northern
beaches
council

DEVELOPMENT DETERMINATION PANEL MEETING

WEDNESDAY 9 AUGUST 2023

ITEM 3.1	REV2023/0011 - 143 & 145 RIVERVIEW ROAD AVALON BEACH - REVIEW OF DETERMINATION OF APPLICATION NO. DA2022/1030 FOR DEMOLITION WORKS, LOT CONSOLIDATION AND THE CONSTRUCTION OF A DWELLING HOUSE
ACTING REPORTING MANAGER	Thomas Prosser
TRIM FILE REF	2023/484868
ATTACHMENTS	1 ↓ Assessment Report 2 ↓ Site Plan and Elevations 3 ↓ Clause 4.6

Figure 1 - Proposed amendments between DA2022/1030 and REV2023/0011

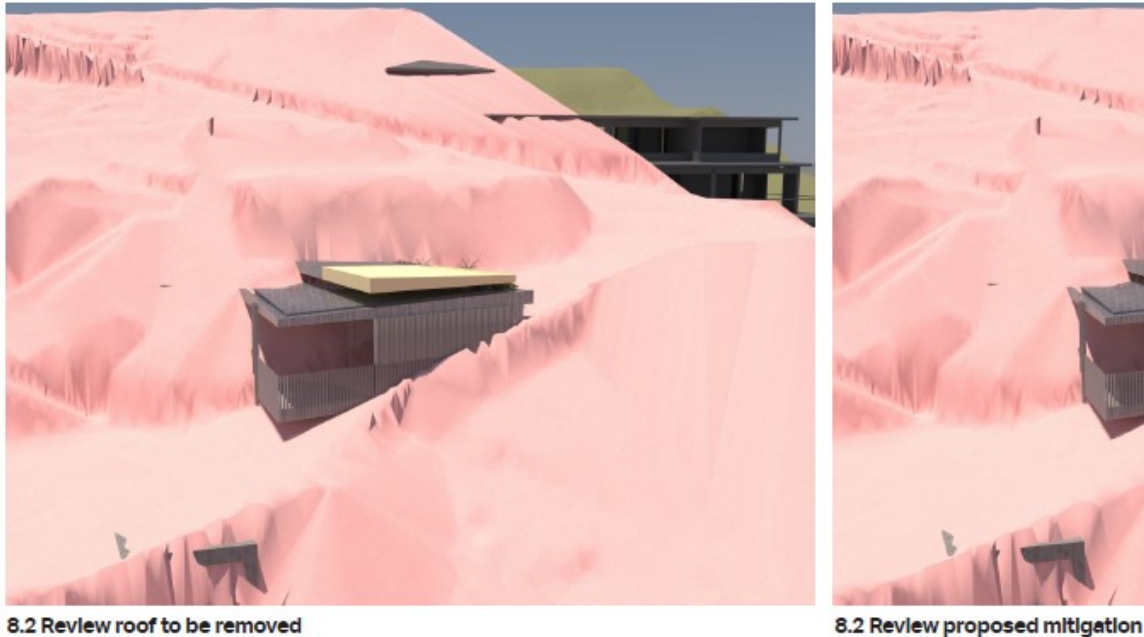
proposal has occurred over the south-west portion of the dwelling roof which has been removed, as pictured below:

Figure 2 - Building height calculation

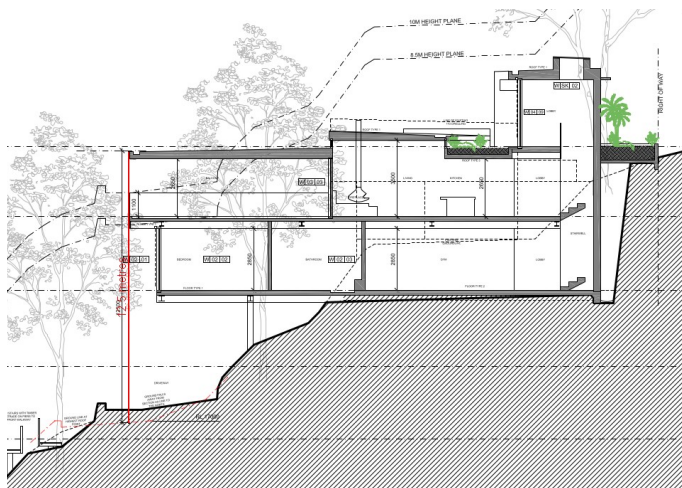
Development standard:	Clause 4.3 <i>Height of Buildings</i>
Requirement:	8.5m
Proposed:	7.8m - 12.5m
Percentage variation to requirement:	47.05%

Figure 1 - South elevation - Building envelope plan prepared by architect . Blue circles mark up by assessing officer showing areas of breach.

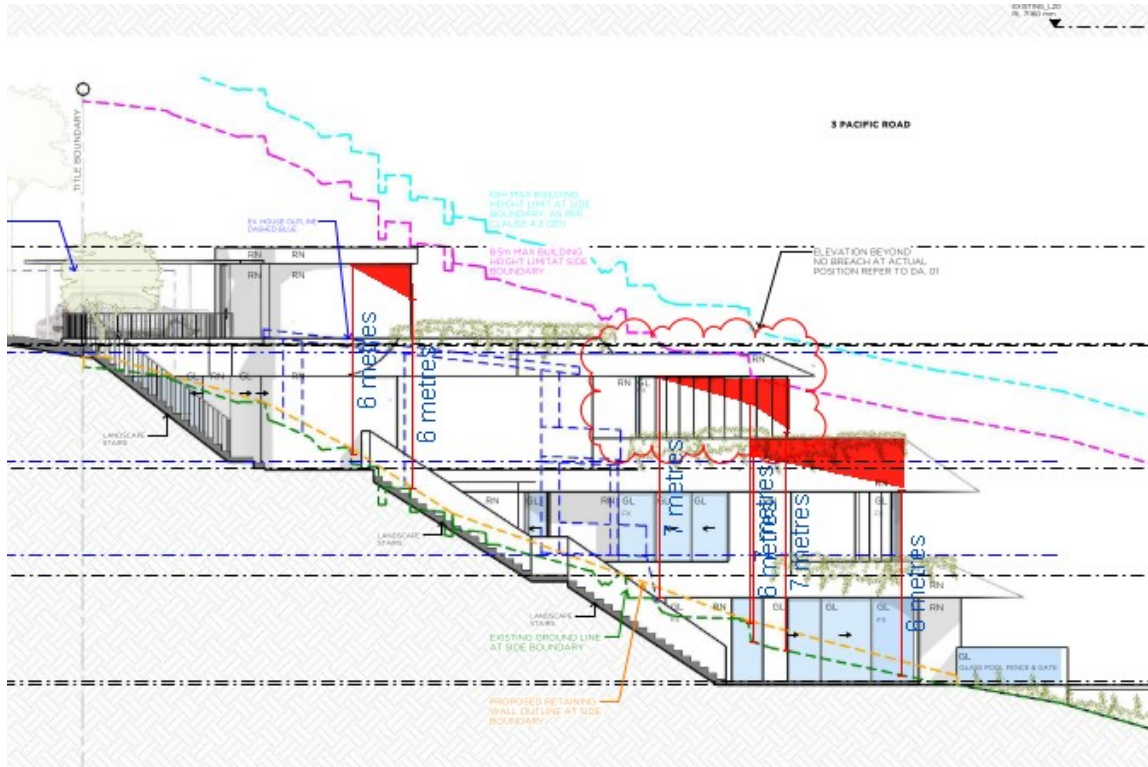
The proposal has an encroachment of the northern and southern side boundary building envelope. The extent of encroachment is displayed in red on the below diagrams:

Figure 9: Tree identification map showing Tree 7 and structural root zone outlined in red.
Source: Hugh the Arborist, 29 March 2023

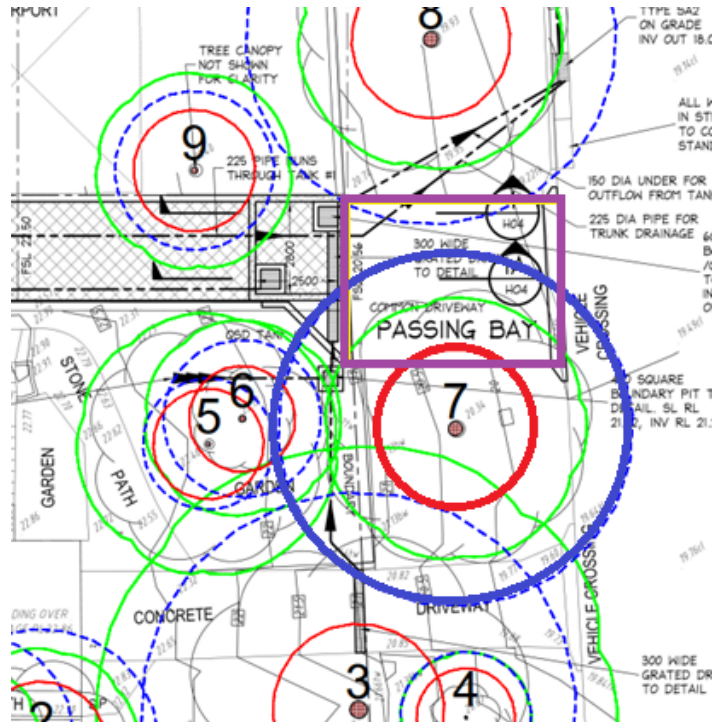
Trees 10 and 11 are identified as exempt species and do not require development consent for removal. Tree 7 is identified in **Figure 9** below, with the red indicating the structural root zone (SRZ), the blue the tree protection zone (TPZ) and the purple delineates the passing bay. The development will result in an encroachment of the SRZ.

Figure 14: Concept plan for development of Lot 3. Existing dwelling at 40 Lakeside Parade. The red indicates windows and the blue is the front door.

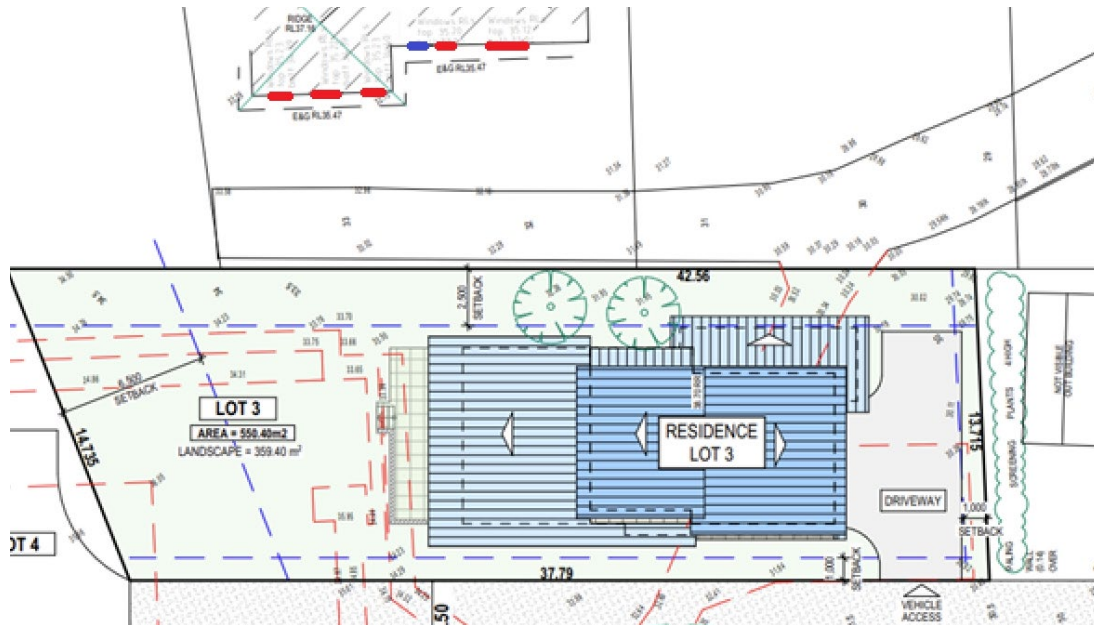
A letter was issued to the Applicant and requested concept plans for the development of the proposed allotments be submitted. The Applicant provided a concept design for Lot 3. The siting of the concept dwelling in relation to the existing dwelling at 40 Lakeside Parade is shown in **Figure 14**.

The existing floor level of 40 Lakeview Parade is approximately RL33.19. The sightlines available from the dwelling would therefore be at a height of RL34.69. The outlook from the dwelling, would be impacted by a dwelling in the position shown on the concept plans.

Figure: 19 Proposed subdivision showing accessway outlined in red.
Source: SDG, 28 March 2023 (CPS markup)

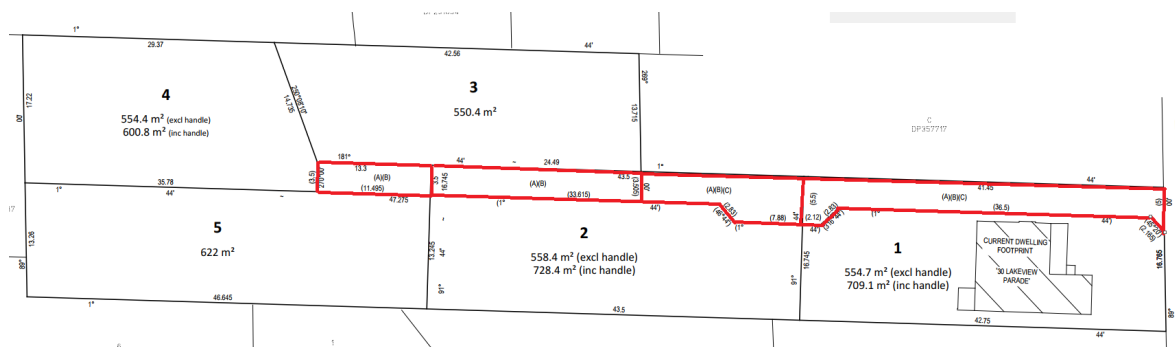
The subdivision proposed as a result of these dimensional variations suggest an overdevelopment of the site.

Figure 21: Tree Location Plan. Green identified tree crown, TPZ shown in blue and red is SRZ.
Source: Hugh the Arborist, 29 March 2023

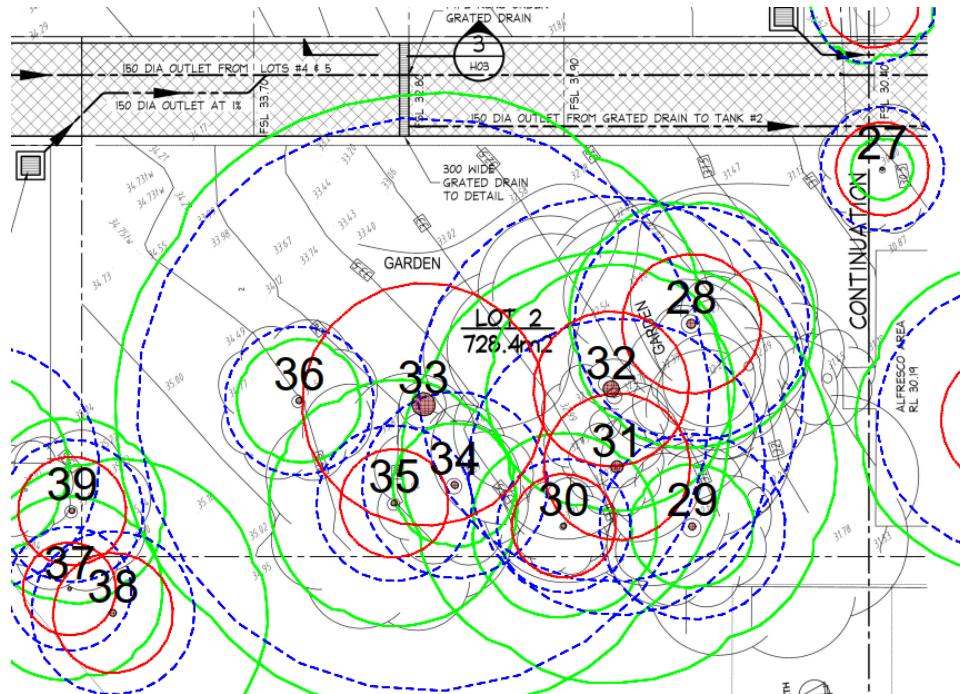
The northern portion of the site contains significant vegetation (Trees 31, 32, 33 and 36) which are identified for retention (**Figure 21**). The significant vegetation results in the building envelope being restricted to the southeastern corner of the allotment.

Figure 25: TPZ and SRZ of significant vegetation location on Lot 4 with concept dwelling shown.
Source: Hugh the Arborist, 29 March 2023

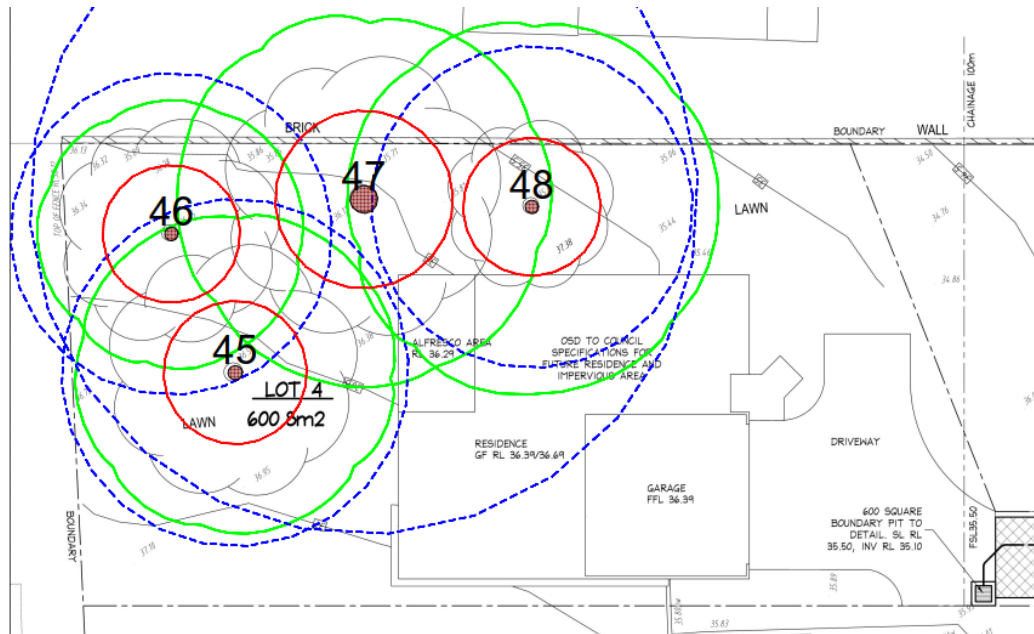
Lot 4 contains significant vegetation to the northeastern corner of the site (**Figure 25**). The vegetation includes 3 x *Melaleuca quinquenervia* (Tree 45, 47 and 48) and 1 x *Araucaria heterophylla* (Tree 46).

Figure 26: Concept plan for Lot 4
Source: JJ Drafting, March 2023

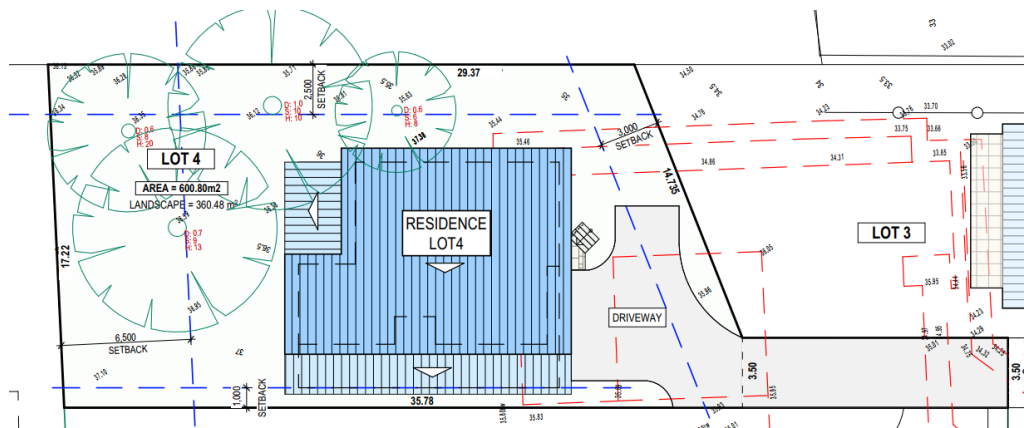
The Applicant has submitted a concept design for the lot (**Figure 26**). The concept plan does not demonstrate the significant vegetation can be retained. It cannot be said that the building would achieve the desired future character of the area and does not overly impact on the environment.

Figure 27: Concept plan for Lot 5
Source: JJ Drafting, March 2023

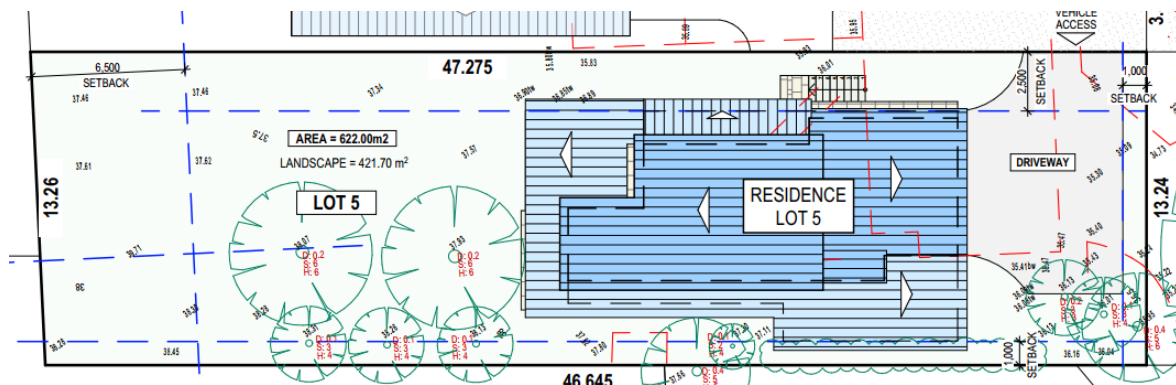
The concept design (**Figure 27**) positions the dwelling towards the southern boundary and locates the driveway with the turning bay within the front setback. The driveway is setback 1m from the southern boundary.

Figure 28: TPZ and SRZ of significant vegetation located on Lot 5 with concept dwelling shown.
Source: Hugh the Arborist, 29 March 2023

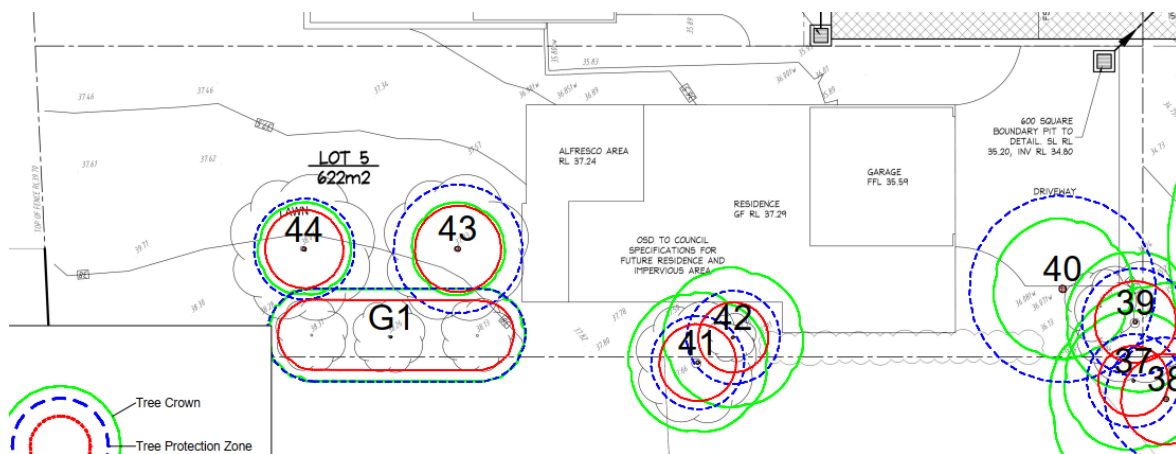
The site contains significant vegetation at the rear (Trees 43 and 44) and within the mid-block adjacent to the western boundary (Tree 42). Tree 41 is located on the adjoining property at 26A Lakeview Parade (**Figure 28**).

Figure 29: Proposed driveway and turning area within Lot 3 outlined in red.
Source: JJ Drafting, March 2023 (CPS markup)

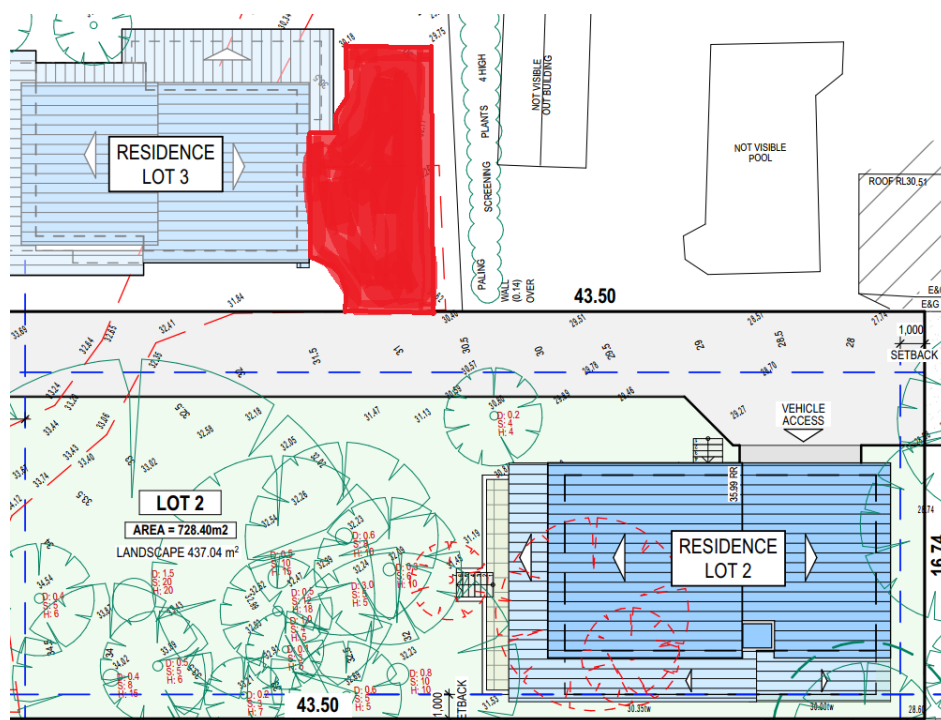
The allotments do not present to the streetscape. However, the development of the lots is nonetheless subject to setback requirements. In response to the RFI, the Applicant indicates Clause D14.7 of P21 DCP will not apply to Lots 2 – 5 as they do not have a street frontage. This position is not agreed with.

D14.7 does not specifically provide variation for battle axe allotments (or non-frontage lots). The PDCP does not include specific controls in terms of building lines or setbacks for battle axe allotments. If there were an intended difference in spatial characteristics for battle axe allotments, then this would be prescribed in the PDCP, but it is not.
